Final Response to Government Agency Submissions and Non- Confidential Public Submissions

Calga Sand Quarry Southern Extension

Major Project Application No.
06_0278

Submitted: November 2012

Glenworth Valley Outdoor Adventures – Page 6

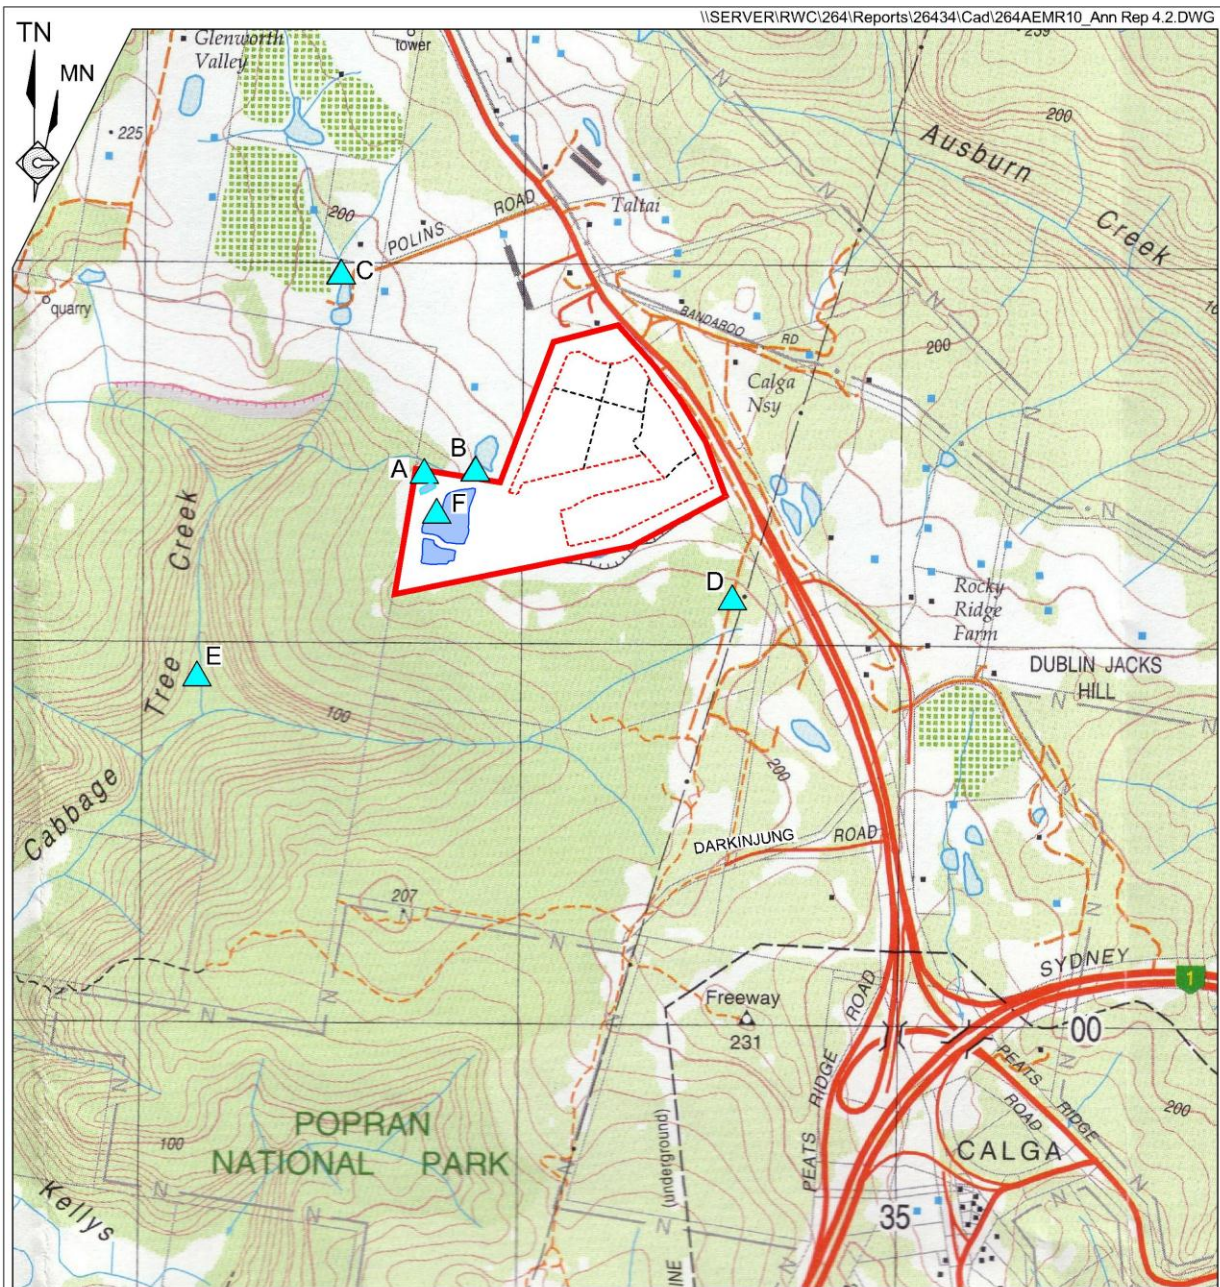
There has been a significant oversight on the subject of the cumulative impacts of the existing and proposed quarry expansion. For instance whilst the Cabbage Tree Creek catchment is quite large there are only 3 watercourses which are or were in the driest of droughts perennial in the entire catchment. These being the creek to the north adjacent to water sampling location C, the creek to the north of the existing quarry adjacent to water sampling location A and the watercourse in the proposed expansion area known as Creek A. These 3 perennial watercourses are highly significant and critical to the survival of numerous plants and animals living in them or relying upon the moisture they provide such as in the extensive high quality rainforest valley below the project site.

The submission identifies three watercourses which, based on personal observation by the author of the submission, were perennial in the “*driest of droughts*” (presumably referring to the 2004-7 drought). The relevance of the three nominated creeks to the proposed project is as follows.

2. The creek immediately to the north of the existing quarry adjacent to water sampling location A drains from the dam on the adjoining property near water sampling location B and receives flow from the diversion weir structure within the existing quarry. Notwithstanding any impact of the existing quarry, it is pleasing to note that the author of the submission has observed perennial flow in this creek. Please note: A copy of Figure 4.2 from the 2011 Annual Environment Management Report more accurately locates the water sampling sites (than *Environmental Assessment* Figure 5.7). This figure is duplicated on the following page.

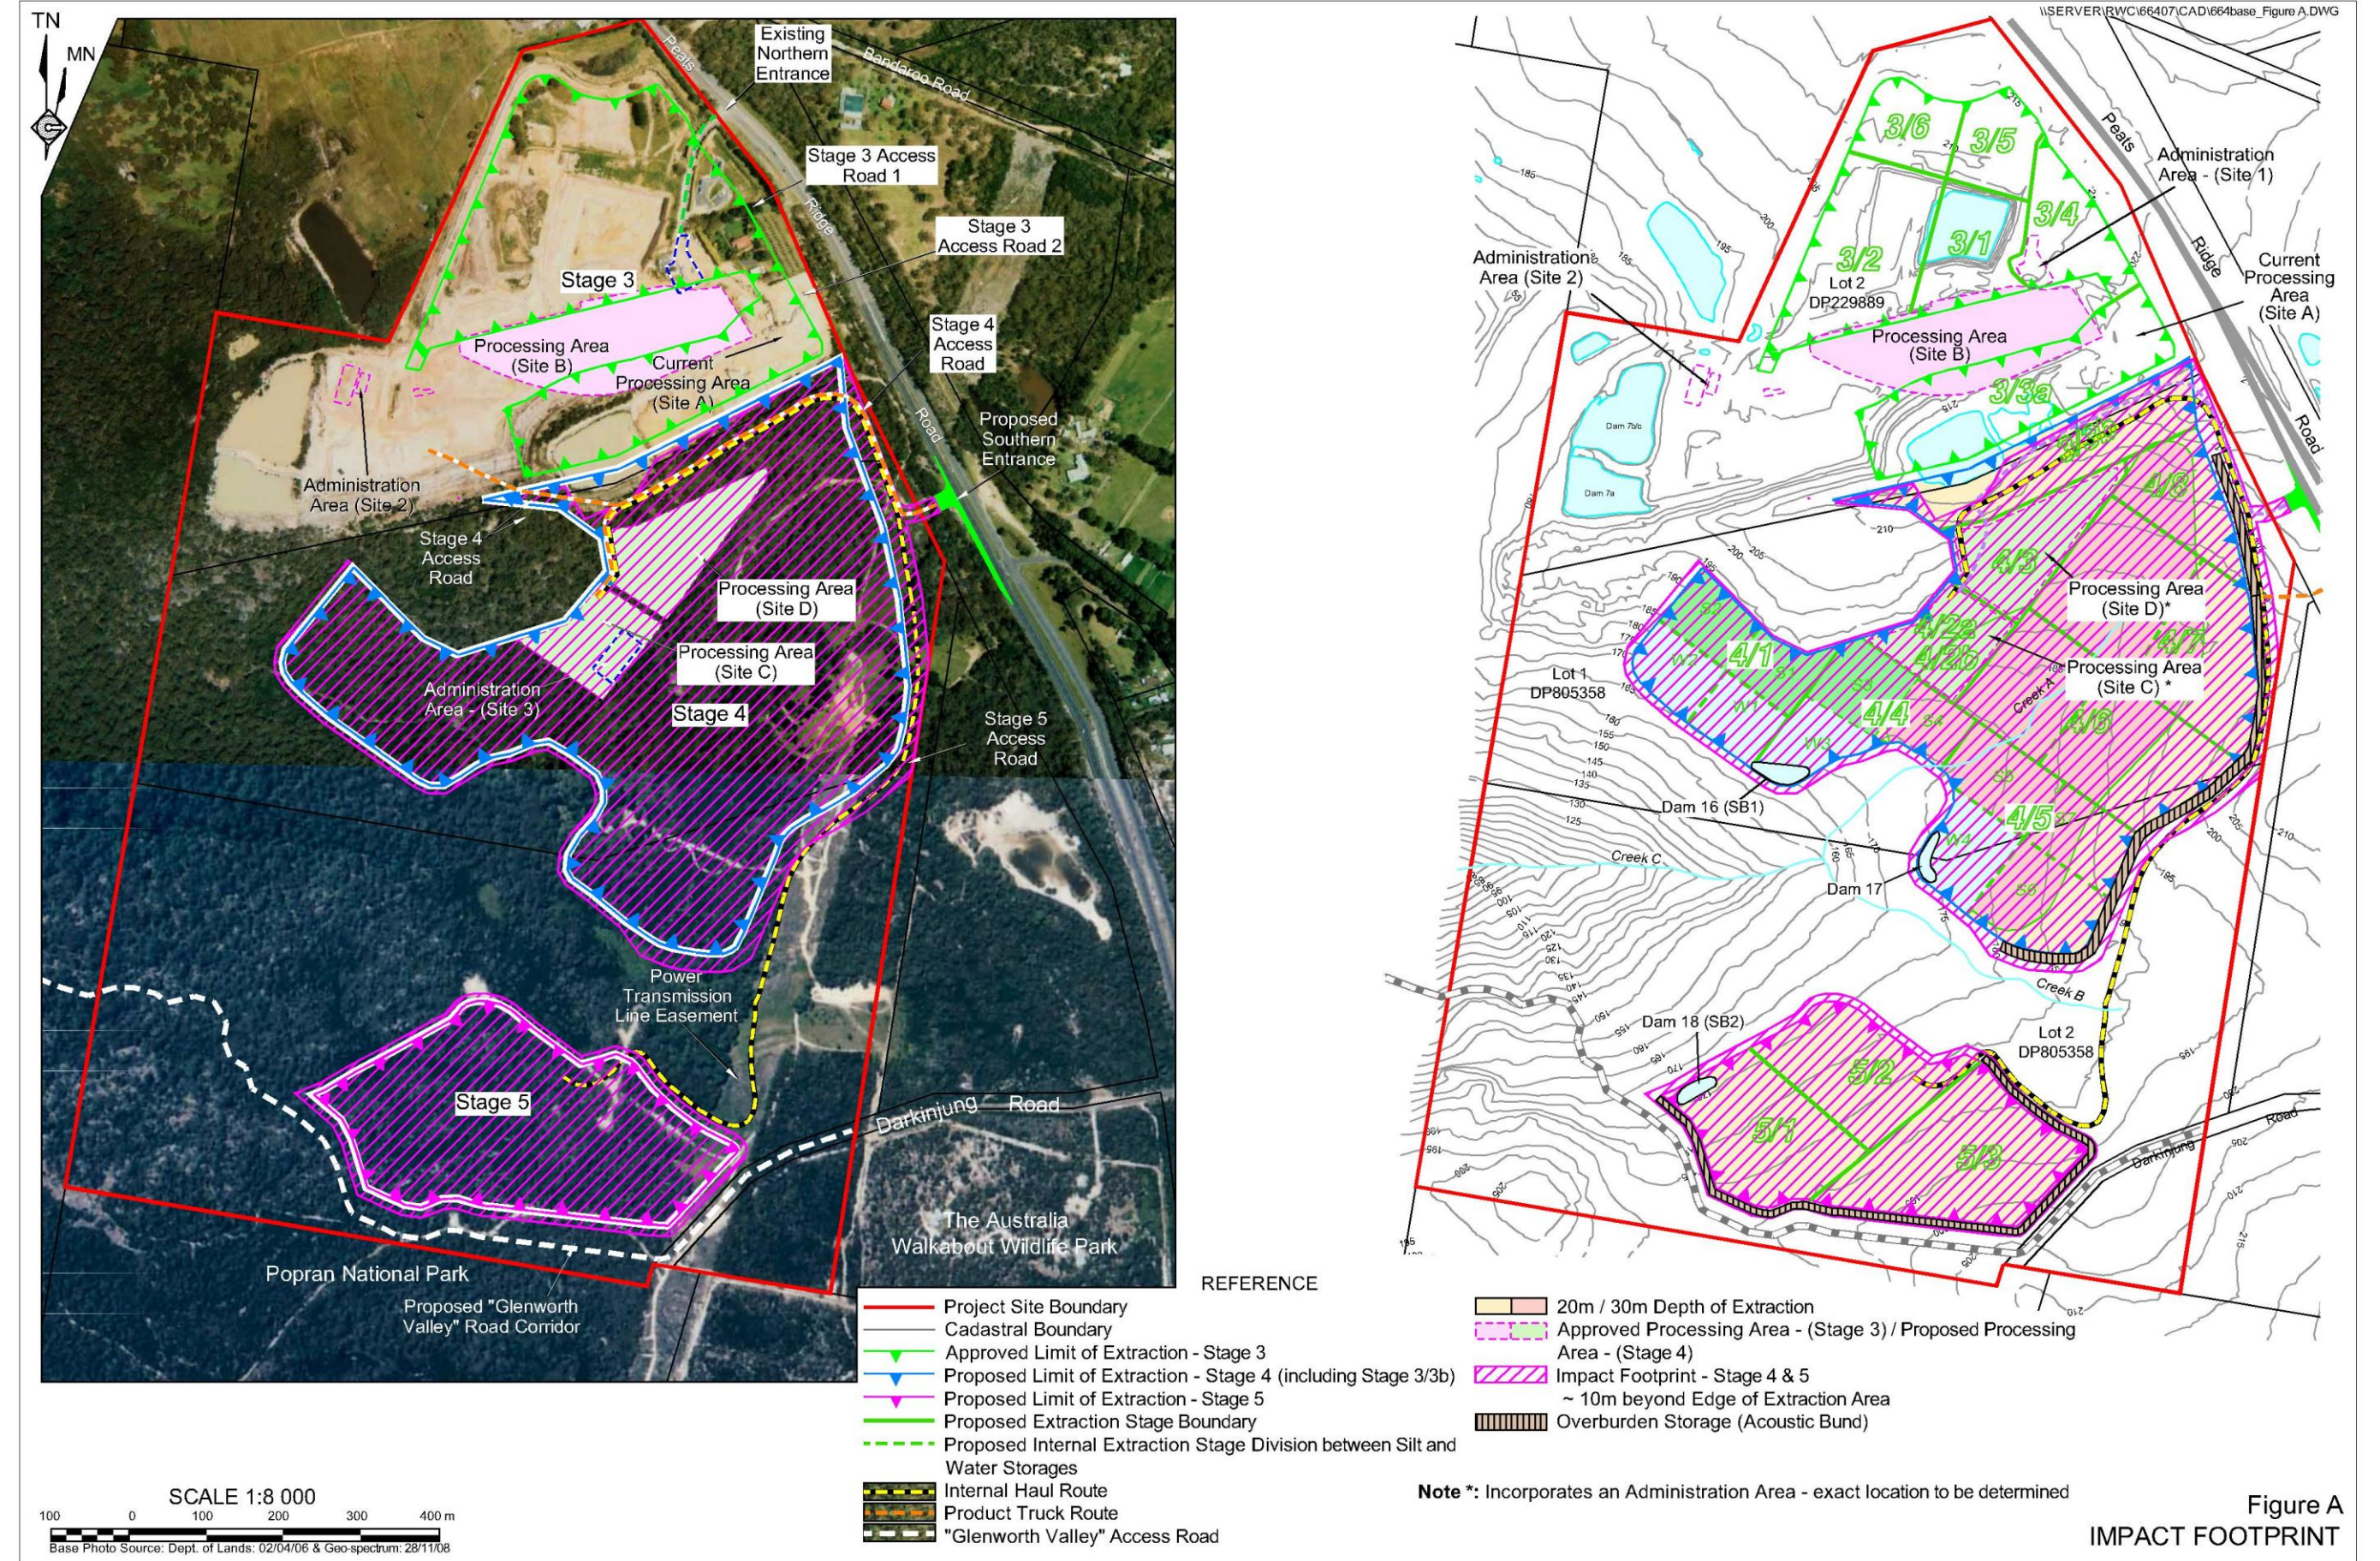
The Impact Area needs to be further defined both in writing and on a figure.

An impact footprint has now been defined around the various activities of the Project that would result in the disturbance of native vegetation (see **Figure A**). As such, the number of individual plants to be disturbed and conserved can be more accurately calculated. The impact footprint incorporates a 10m wide area around sections of Stages 4 and 5 providing access for fencing, etc. The walking track to the engraving site #45-3-0119 would also be located within the 10m wide area, noting however, the extent of vegetation clearing would be minimal within this 10m wide area. EA **Table EA-5.20** has been reviewed and updated to include the individual threatened flora species occurring within the impact footprint.

Figure A has been prepared to better illustrate the impact footprint of the proposed Southern Extension. The following aspects of the Project are specifically identified on **Figure A**.

- Stage 4 and 5 extraction areas. (Note: the boundaries of both areas have been modified to accommodate the results of the Supplementary Aboriginal Heritage Assessment)
- Internal access roads.

- Glenworth Valley Access Road Corridor. (Note: the alignment of the corridor has also been modified slightly)
- Dams and water ways external to the extraction areas. It is noted that Dam 18 (SB2) has been relocated to within the Stage 5 extraction area.

Around the majority of the extraction area, an impact footprint of approximately 30m has been assumed (which will include the proposed acoustic bunds and external dams) to account for miscellaneous disturbance associated with roads, stockpiles and water diversionary structures. The impact footprint has been restricted to the extraction area, however, where the perimeter has been modified to avoid areas of environmental or cultural heritage sensitivity. These areas will be carefully pegged prior to commencement and all activities managed to ensure disturbance remains within the pegged area. Commitments 6.1 and 8.2 to 8.4 reinforce the intention of the Proponent to restrict disturbance in these areas.

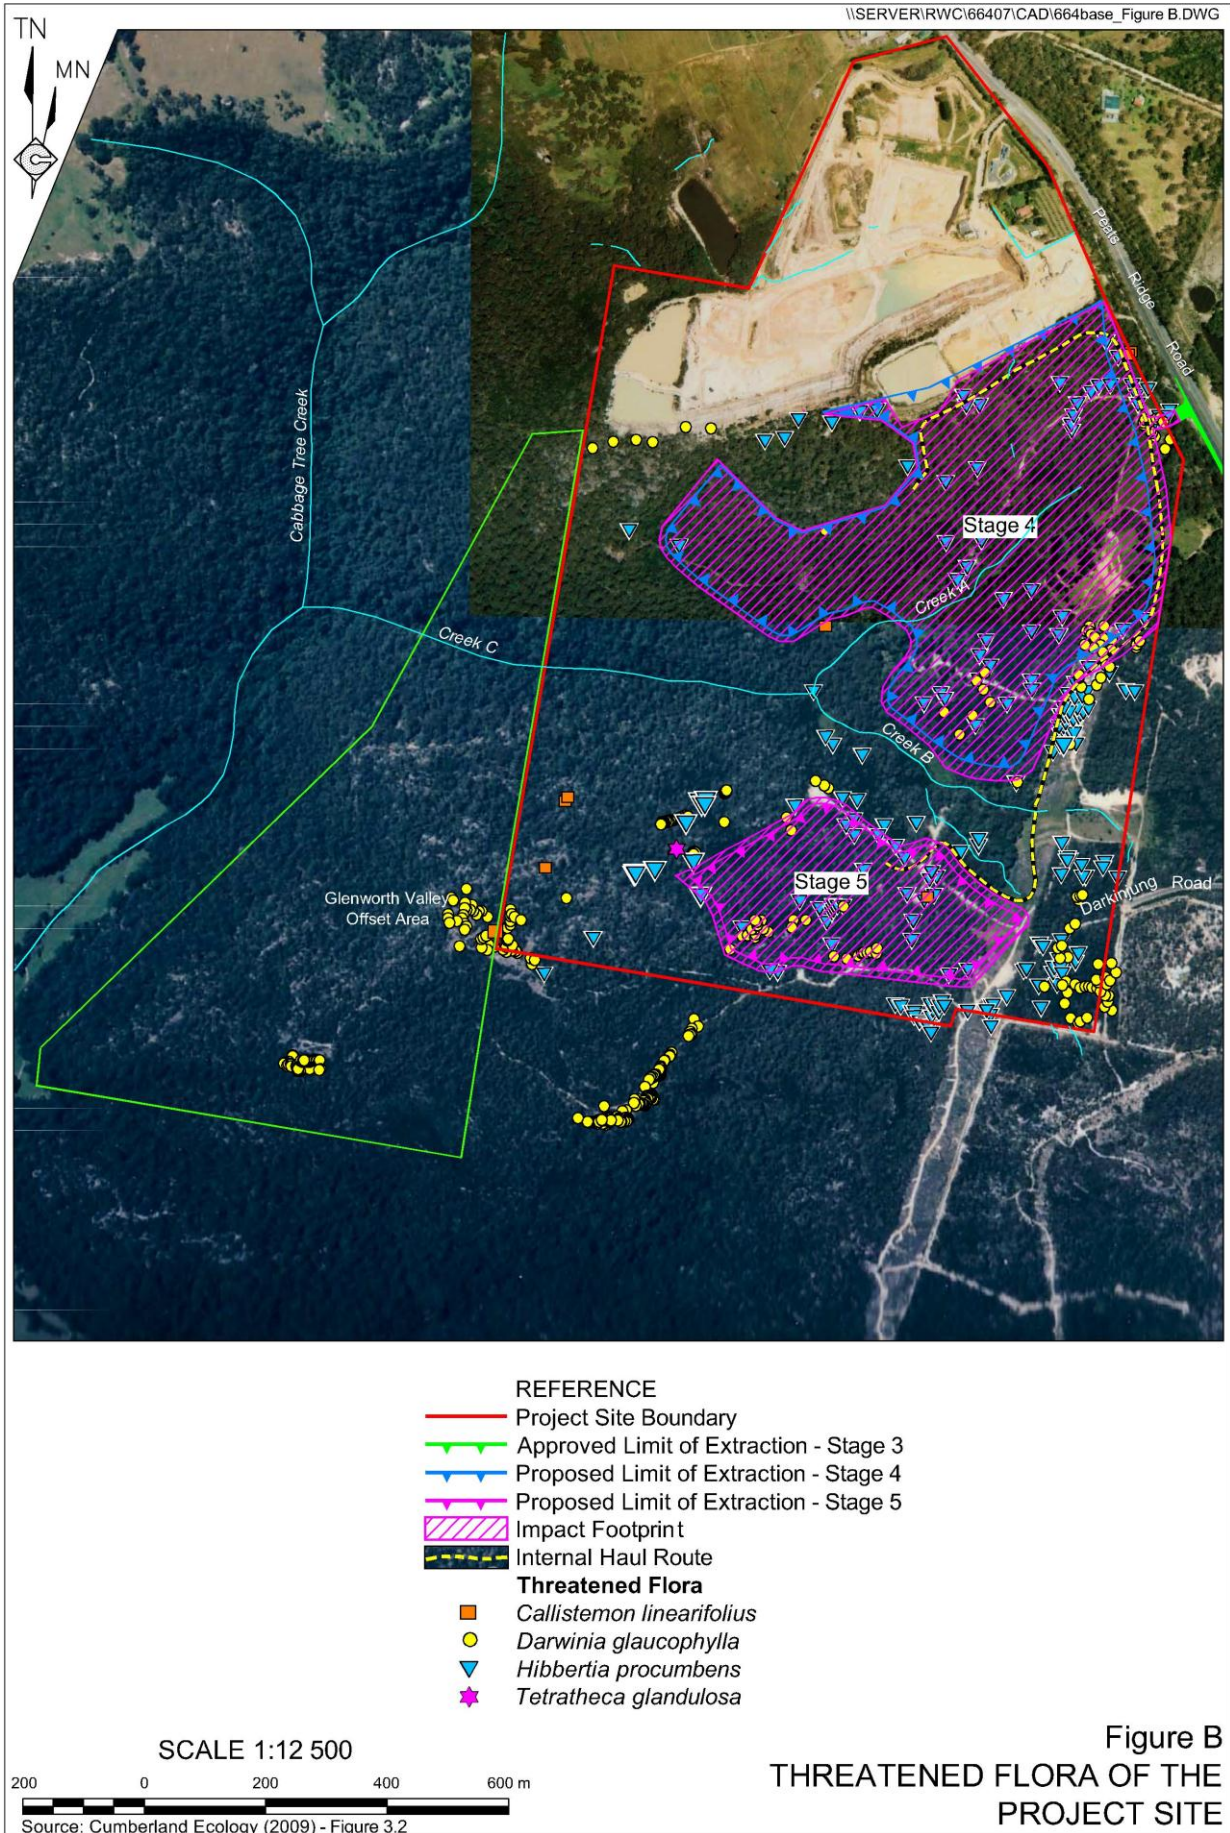
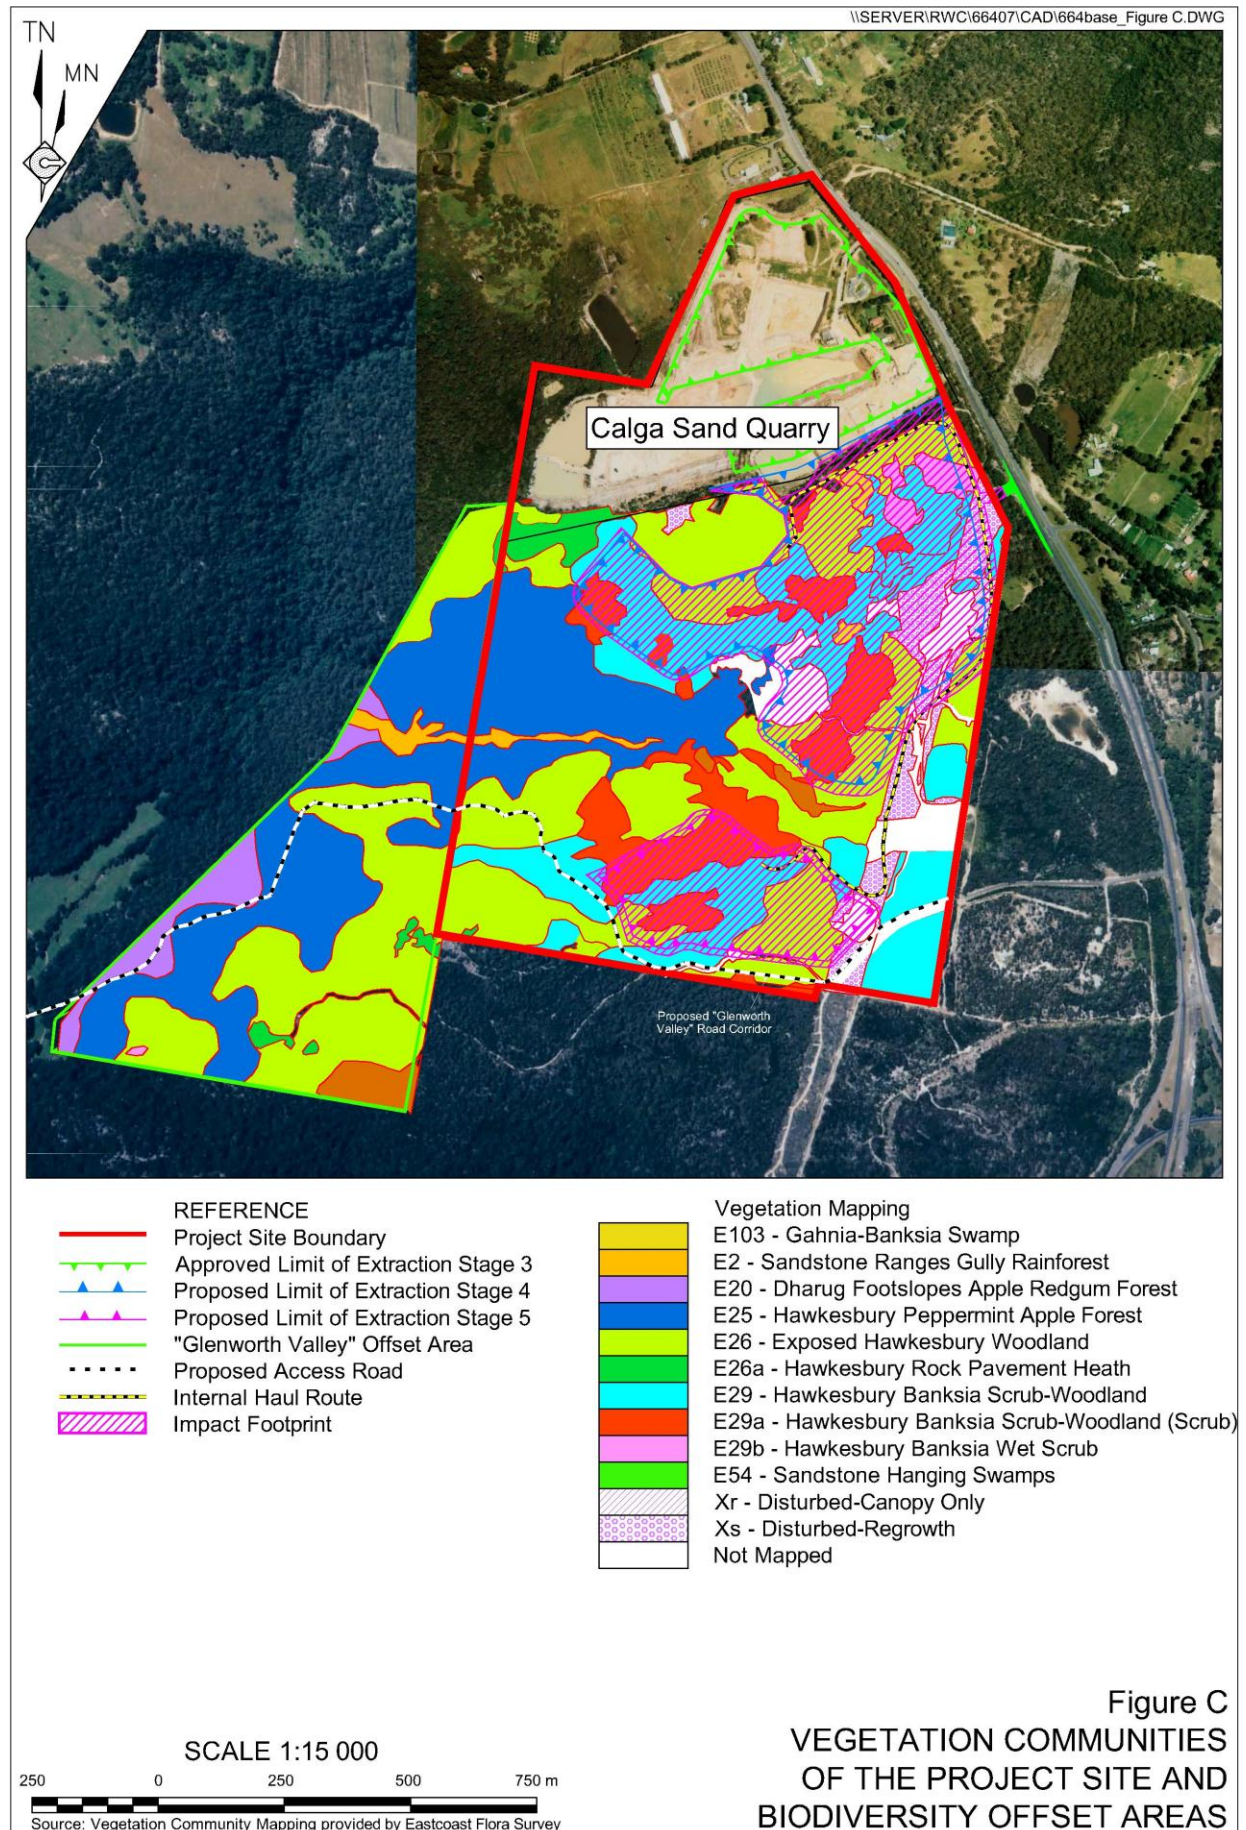
DECCW has undertaken a review of the Surface Water Assessment (Evans and Peck 2008) in regards to impacts upon threatened species and the Biodiversity Offset Area. A number of diversion banks and controlled waterways (spillways) have been placed within the Biodiversity Offset Area, whilst it is acknowledged that these facilities are required for a proposal of this nature, the impact on the biodiversity offset area, particularly threatened flora species, has not been addressed.

*In addition, Dam 18 (sediment basin 2) appears to have been located in the same position as the only *Tetratheca glandulosa* record for the site. DECCW notes that the Offsets Report includes this plant as being retained within the Offset Area. The security of this plant therefore needs to be clarified.*

Figure C provides an illustration of the disturbance footprint over the vegetation mapping of **EA Figure 5.15**. **EA Table EA-5.21** has been updated based on the impact footprint defined on **Figure C**.

The nominated water management structures have now been included within a revised impact footprint. Notably, Dam 18 (SB 2) has been relocated to within the Stage 5 extraction area to reduce the impact on the recorded *Tetratheca glandulosa* on the Project Site². EA **Table EA-5.20** has been reviewed and updated to include the individual threatened flora species occurring outside the extraction areas and other nominated areas of disturbance but within the 30m buffer zone.
